# Intel Technical Advisory

TA-1047-1

**Customers may experience system shutdown and then reboot in power supply redundancy mode when inserting or removing any one of the power supply units, or when system encounters unexpected power supply unit failure.**

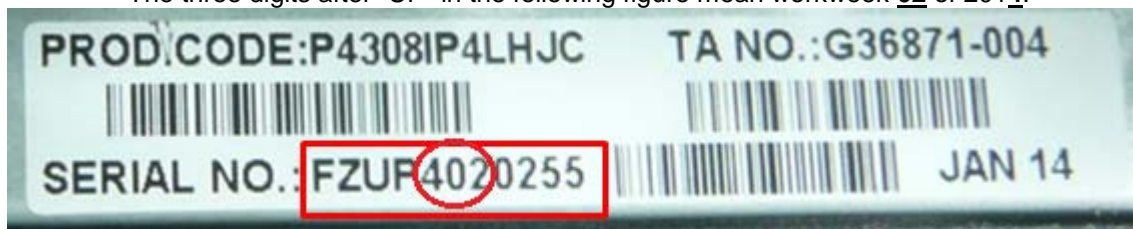
Intel has determined the Intel® Server System P4000IP4 and Workstation System P4000CR2 using power supply redundancy function with serial number before workweek 02 of 2014 may be affected by this issue. Customers can identify the workweek by referring to the following example.

The three digits after "UP" in the following figure mean workweek **02** of 2014.

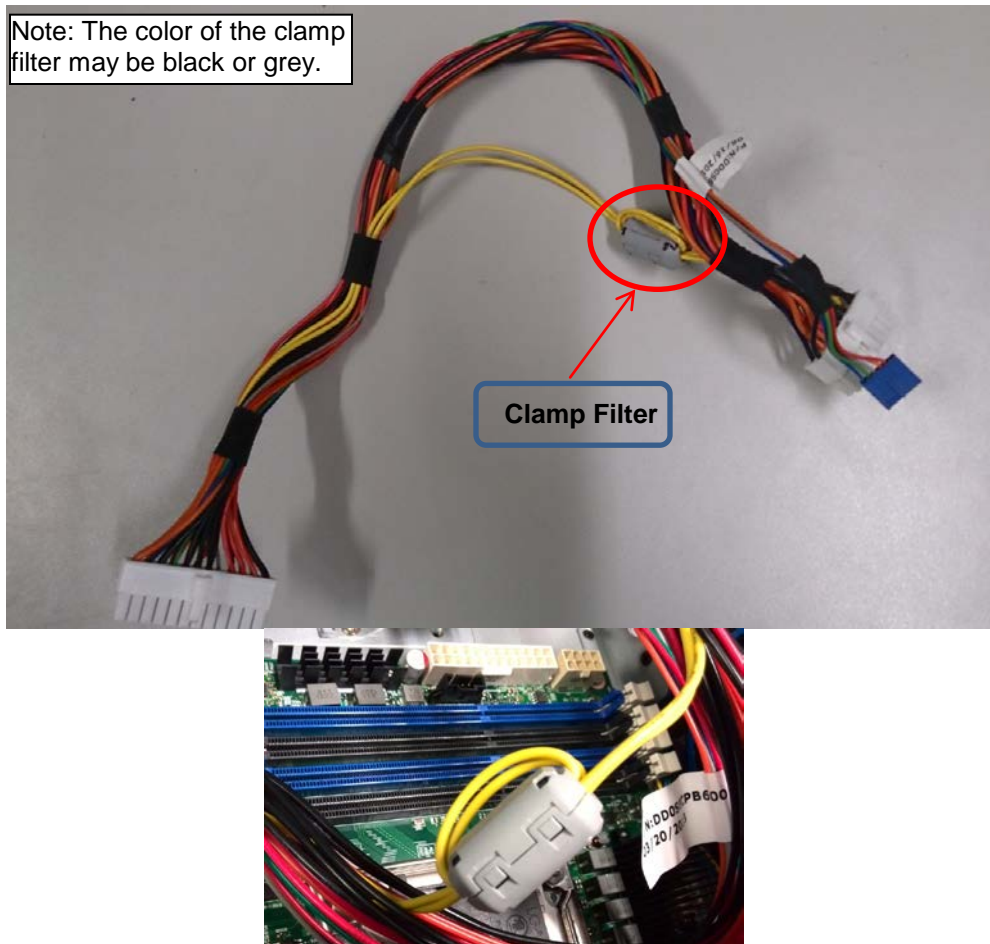
When inserting or removing of one power supply unit, or unexpected power down of any one of the power supply units occurs, the noise from P12V coupled to adjacent signal wires in the same cable bundle may cause the voltage of the remote sense signals to fluctuate beyond their voltage thresholds, and induce the failure of power supply redundancy mode, depending on cable assembly state.

Intel is implementing a clamp filter onto the P12V power wires to fix the issue. For the Intel® Server System P4000IP4 and Workstation System P4000CR2 that have the power supply redundancy function, Intel recommends customers replace the cable set with the clamp filter pre-installed cable.
